# HISTORIC AND DESIGN REVIEW COMMISSION

**HDRC CASE NO:** 2019-632  
**ADDRESS:** 314 LAMAR ST  
**LEGAL DESCRIPTION:** NCB 528 BLK 1 LOT 4  
**ZONING:** R-5, H  
**CITY COUNCIL DIST.:** 2  
**DISTRICT:** Dignowity Hill Historic District  
**APPLICANT:** Timothy Patrick/FDN Home, LLC  
**OWNER:** 10X Properties Investments Series, LLC  
**TYPE OF WORK:** Rehabilitation, construction of a rear addition, and construction of a rear accessory structure  
**APPLICATION RECEIVED:** October 18, 2019  
**60-DAY REVIEW:** December 17, 2019  
**CASE MANAGER:** Edward Hall  
**REQUEST:**

The applicant is requesting a Certificate of Appropriateness for approval to perform rehabilitation, exterior modifications and to construct a rear addition at 314 Lamar. Within this request, the applicant has proposed the following:

**NEW WORK REAR ELEVATION**  
SCALE: 1/4" = 1'-0"

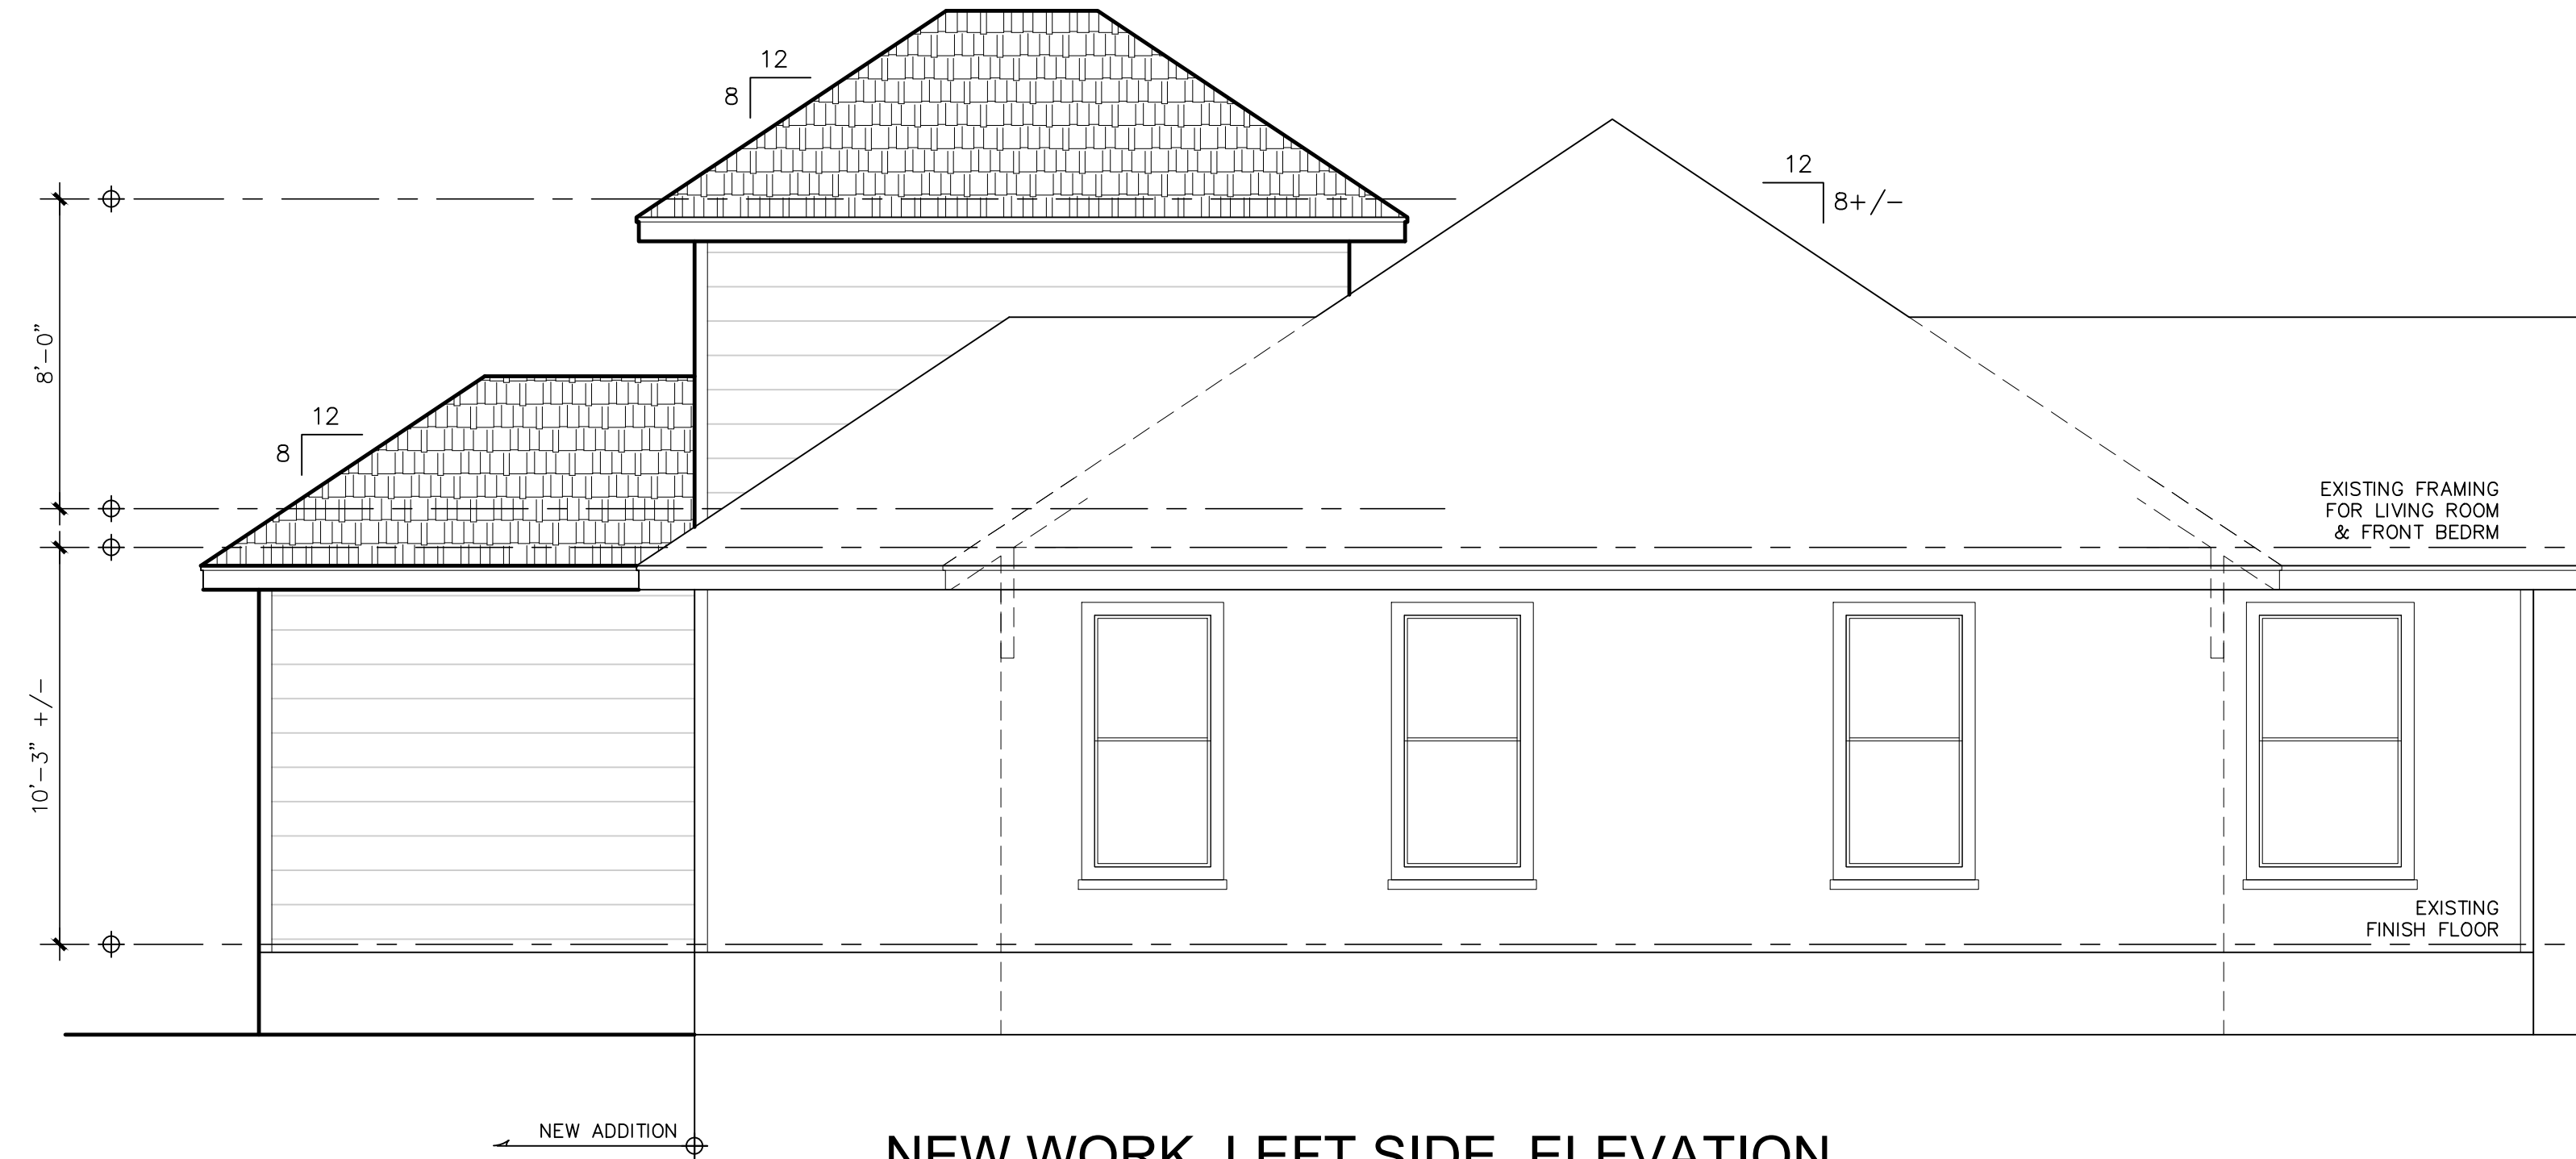
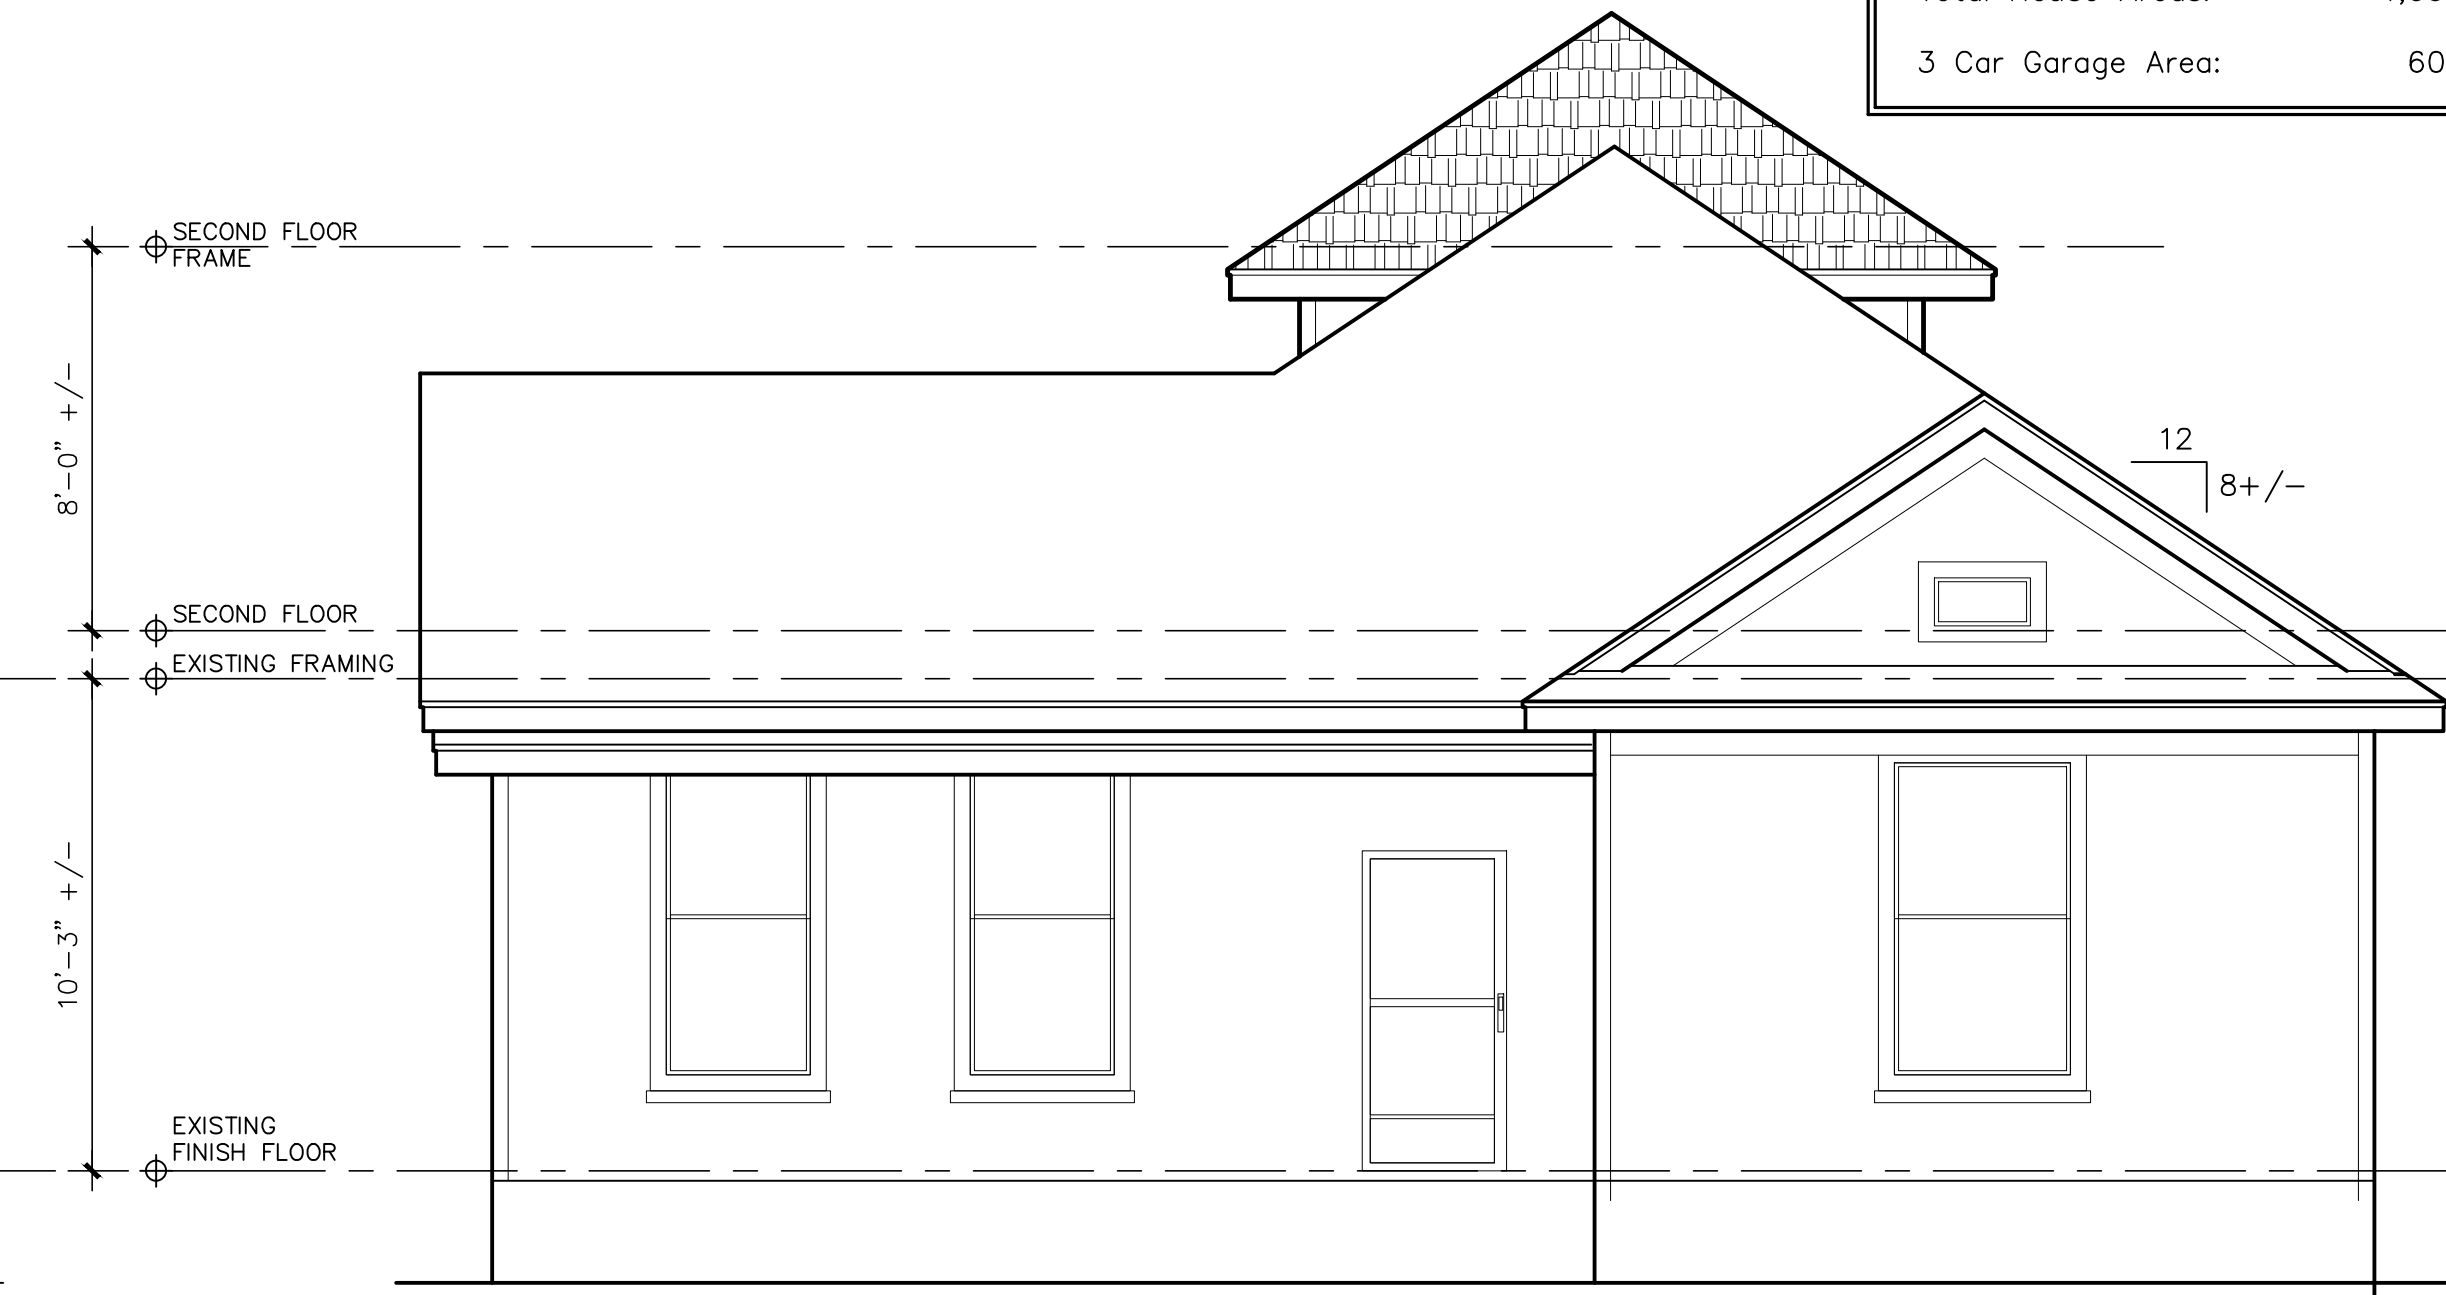
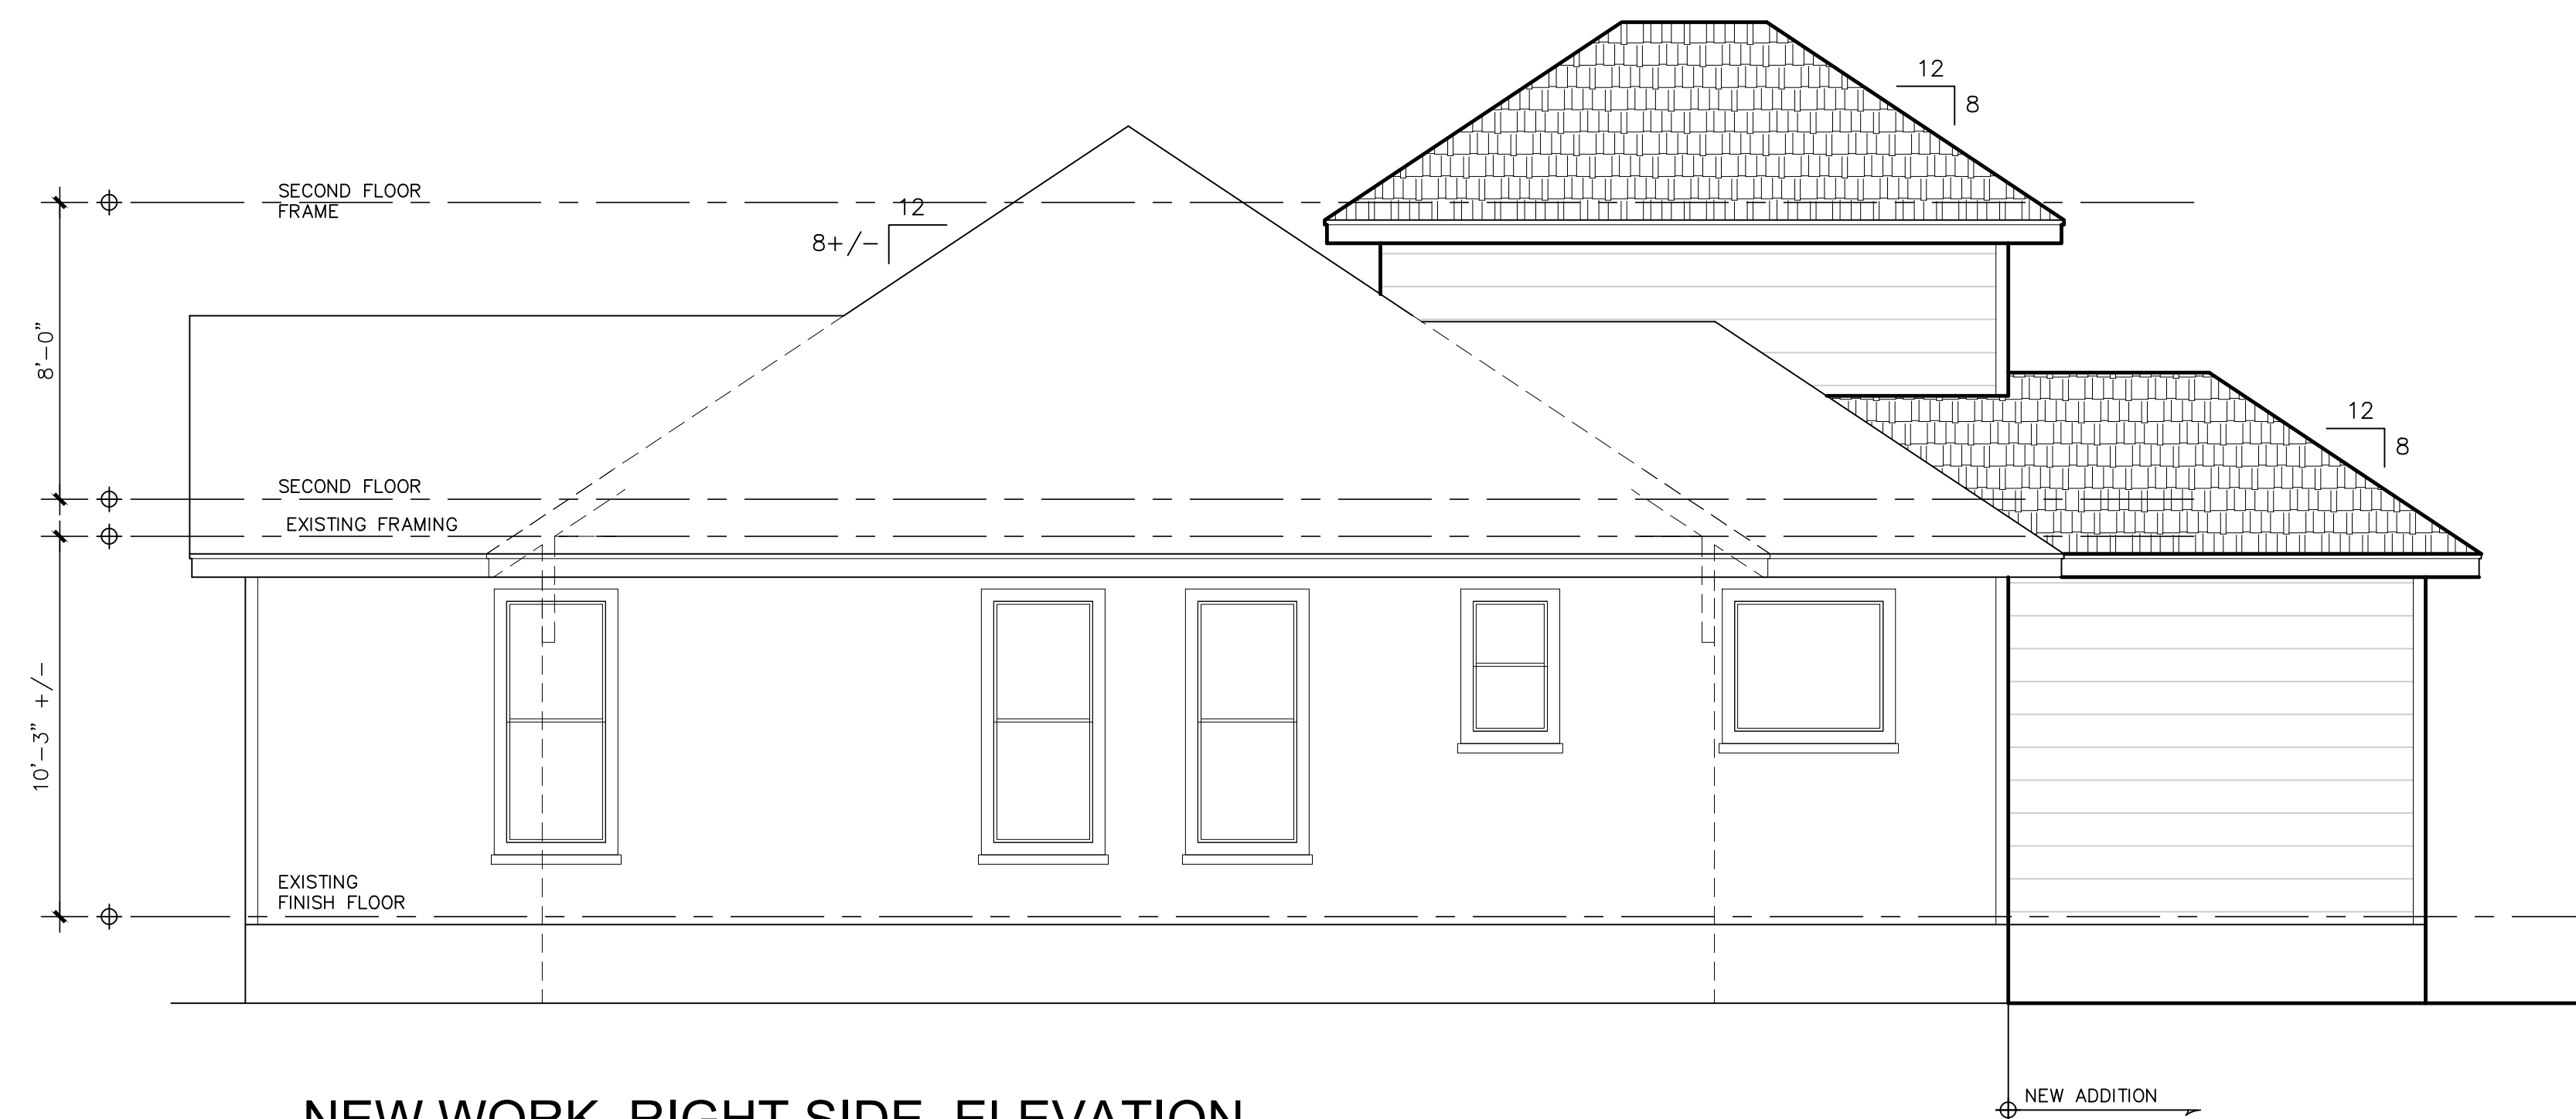
- g. **ROOF FORM** – The Guidelines note that roof forms should be comparable to those found on the historic house. Staff finds the roof form of the one story structure to be appropriate; however, staff finds that the roof form of the proposed two story addition to feature proportions that are inconsistent with those of the historic structure's roof.

- h. **HEIGHT** – The applicant has proposed an addition that features a second story element that is not subordinate to the height of the primary historic structure. Staff finds that the applicant should submit a line of sight study to provide additional information regarding the proposed addition's visibility from the right of way at Lamar and how the proposed addition may impact the historic structure's primary façade from the right of way at Lamar.

- k. ARCHITECTURAL DETAILS – Generally, staff finds the architectural details of the one story addition to be appropriate; however, staff is concerned regarding the height, profile and roof form of the proposed two story addition. Staff finds that the applicant should revise the proposed design to feature less of a tower massing and feature a massing and profile that is more in keeping with the that of the historic structure.
- l. REAR ACCESSORY STRUCTURE – The applicant has proposed to construct a rear accessory structure; however, the applicant has only provided a site plan for the structure at this time. Staff finds that the applicant should submit sufficient construction documents for this structure prior to staff providing a recommendation.

- 3. Staff does not recommend approval of item #3, the construction of a rear addition based on findings f through k. Staff recommends that the applicant modify the proposed roof form, massing and architectural details to be more in keeping with those of the historic structure and that does not modify the roof form of the historic structure. Additionally, staff recommends that the applicant submit a line of sign study to determine the appropriateness of the proposed rear addition's height. The proposed rear addition should not been visible when viewed from the right of way.
